**Federal Motor Vehicle Safety Standard (FMVSS) No. 213 Test Procedure  
(TP-213-11) Docket No. NHTSA-2023-0067**

This document serves as the response of Iron Mountains, LLC (“IM”) and the Iron Mountains Testing Center (“IMTC”) to NHTSA Docket No. NHTSA-2023-0067. It contains comments on the updated OVSC laboratory test procedure, TP-213-11, which includes instructions for how labs should test for compliance with the recently created FMVSS No. 213a, *Child restraint systems—side impact protection*. Iron Mountains, LLC thanks NHTSA for the opportunity to provide input to this test procedure.

Figure 3: Door Ledge Proposal to Secure Door Foam

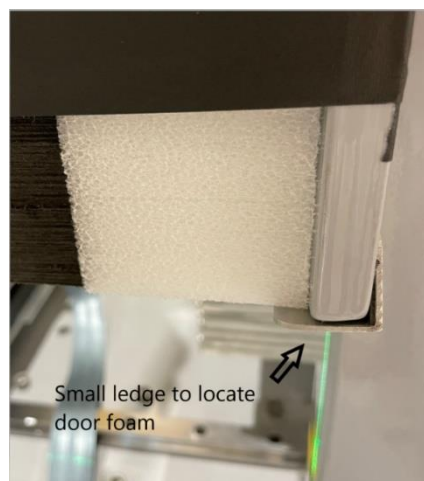
Using tape as the sole method for securing the door and armrest foams to the steel door fixture plate is cumbersome and creates variation in foam position. IMTC believes a narrow ledge attached to the bottom of the door fixture to secure the foam could be a robust and cost-effective solution that would reduce variation in test set-up and increase reproducibility (see Figure 3). IM recommends that NHTSA study the feasibility of implementing such a design.

Figure 4: SISA Sliding Seat Acceleration vs. Time of Door Contact

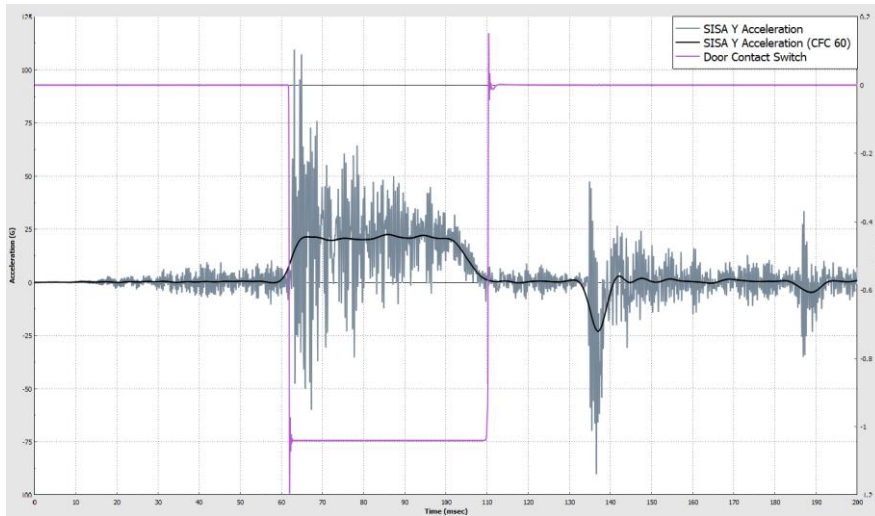
The correct or most appropriate method for measuring time of initial contact,  $T_0$ , is unclear. TP-213-11 defines  $T_0$  as the time the SISA sliding seat first contacts the door assembly, as measured by a contact switch sensor between the SISA sliding seat and honeycomb. SAE J211-1 (1995) states, "Time of initial contact (real or simulated) ... can be accomplished by recording a switch actuated by the impact or by observing the instant the test acceleration exceeds a predetermined value (for example, 0.5 G)."<sup>2</sup> Internal and external FMVSS 213a crash test studies conducted by IM show that the two methods can yield different results and it is unclear which method should take precedence.

In a FMVSS 213a side impact test, SISA sliding seat contact with the door causes a high rise in the SISA sliding seat acceleration data set. After the CFC 60 filter is applied, the resulting filtered data follows the same pulse response described in SAE J211-1 (1995) Appendix C, Figure C2 and no longer aligns with the  $T_0$  measured by contact strip. This is illustrated by the test data shown in Figure 4 below. Here, the filtered SISA Y Acceleration (CFC 60) curve suggests that the SISA sliding seat acceleration was approximately 8 G at time contact switch actuation ( $T_0 = \sim 62$  ms); however, the unfiltered SISA Y Acceleration curve proves otherwise.

The language of TP-213-11 and the coordinates defining the SISA sliding seat acceleration and Relative Velocity corridors suggest that the corridors begin at time of initial contact, as measured by the contact strip. In the case of the SISA sliding seat acceleration, this is not feasible in practice due to the CFC 60 filter response described above.

Figure 5: MGA Relative Velocity & SISA Sliding Seat Acceleration vs. Time of Door Contact

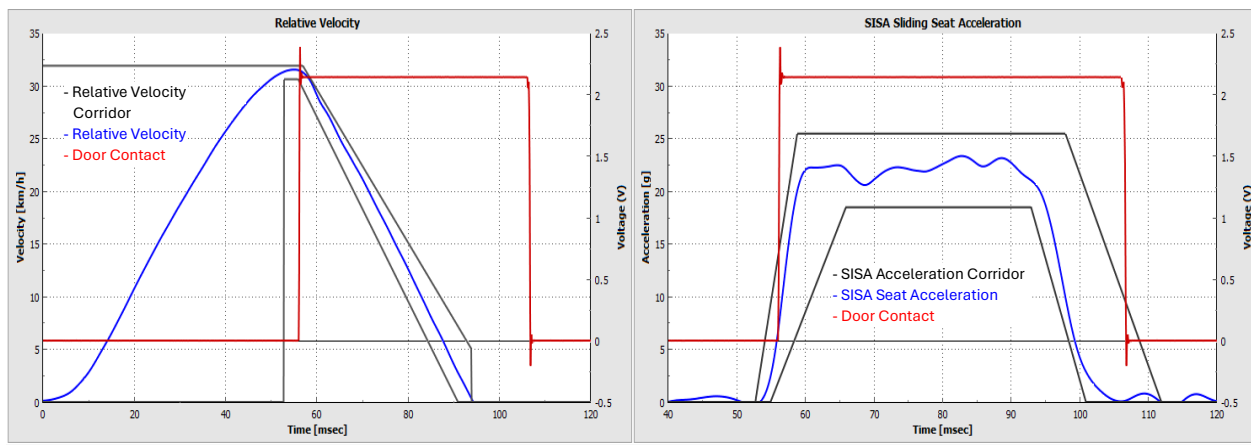
The method to define time of initial contact is not consistent between the contract test labs. Calspan uses contact switch actuation to record  $T_0$  at time of initial contact. All data channels are initially time shifted to this value. Calspan will then manually reset  $T_0$  within DIADEM such that the SISA sliding seat acceleration and Relative Velocity curves fall within the respective corridor. Per Calspan sled technicians, the corrected  $T_0$  is typically 3-5 ms later than the initial time of contact measured by the contact switch. All data channels are then reprocessed to reflect the corrected  $T_0$  and then time shifted such that  $T_0$  occurs at 0 ms. MGA Research Corporation (“MGA”) follows SAE J211-1 (1995) guidelines and uses a mechanical trigger device mounted on the main sled carriage to observe the instant the carriage experiences a 0.5 G or greater impulse. The contact switch is used to calculate the Relative Velocity. The SISA sliding seat acceleration and Relative Velocity corridors do not begin door contact actuation (see Figure 5).

Figure 10: Q3s Arm Angle Device for Rear-facing Test Conditions

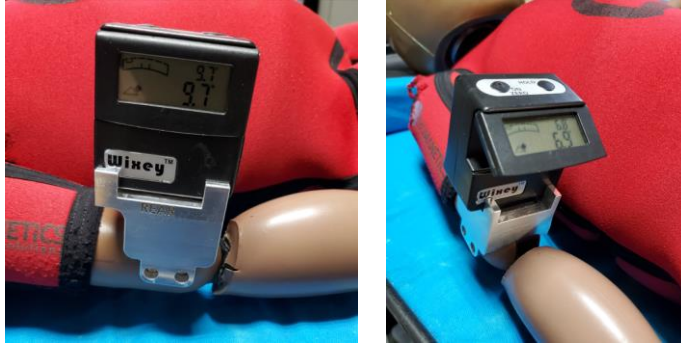
There is approximately  $5^{\circ}$  of play in the Q3s arm position after the arm is engaged in the shoulder detent. IMTC has found that using the ATD thorax tilt sensor in conjunction with an inclinometer mounted to the two holes in the elbow skin to be a more accurate measurement of ATD arm angle relative to the thorax. Graco's Q3s Arm Angle Device shown in Figure 9 and Figure 10 has proven to be a useful tool for mounting the inclinometer and IM supports implementation of this device into the FMVSS 213a test procedure.

Figure 11: FMVSS 213a Repeatability and Reproducibility Results for RF Convertible CRS

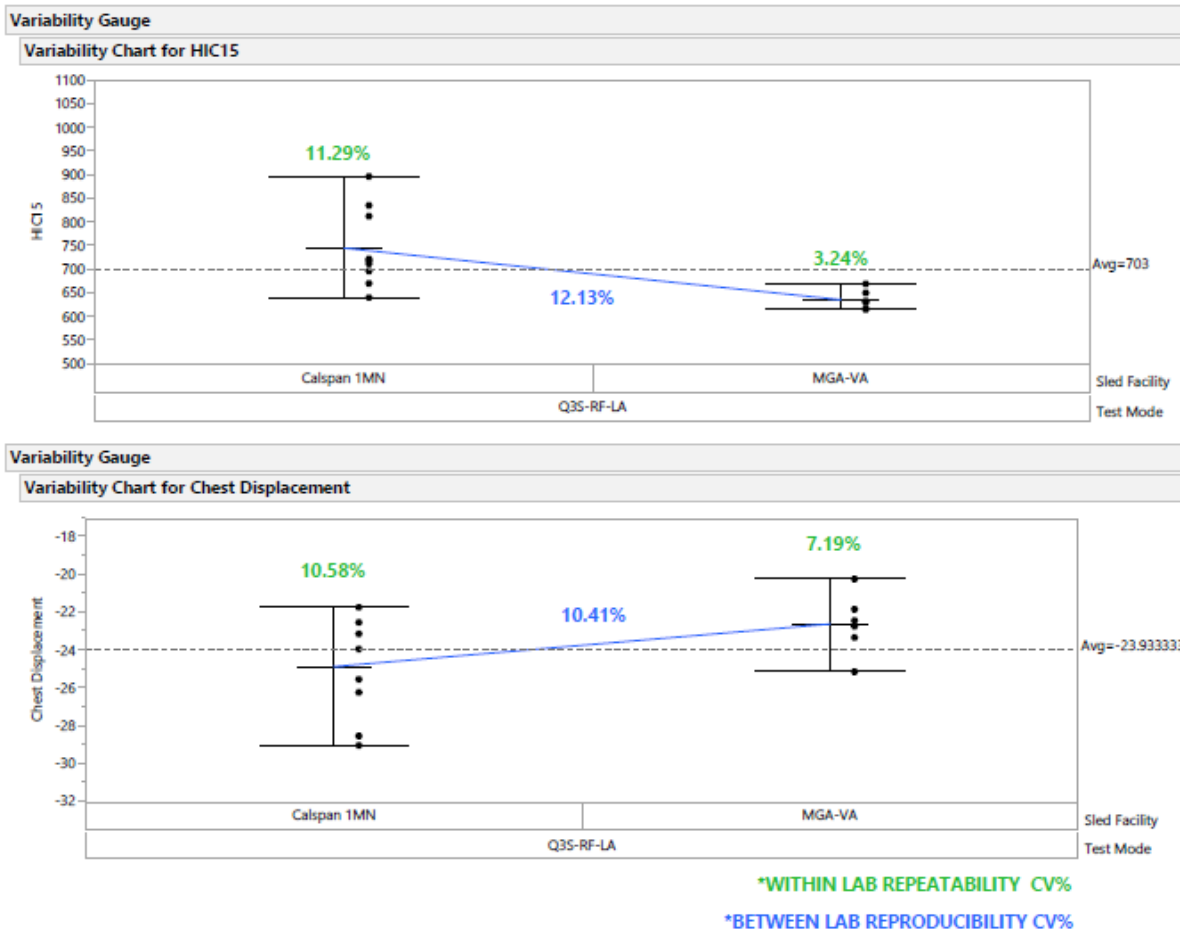
Figure 11 summarizes the repeatability (within lab) and reproducibility (lab-to-lab) results from a recent (February 2024) FMVSS 213a crash test study conducted by IM and associated companies at the contract test labs. Results show marginal<sup>4</sup> reproducibility with a lab-to-lab coefficient of variation (CV) value greater than 10% for the single, current production rear-facing (RF) convertible CRS model evaluated. The CV values generated in this study are greater than those achieved in the NHTSA repeatability and reproducibility study<sup>5</sup>, indicating a need for improvement to the test procedure.
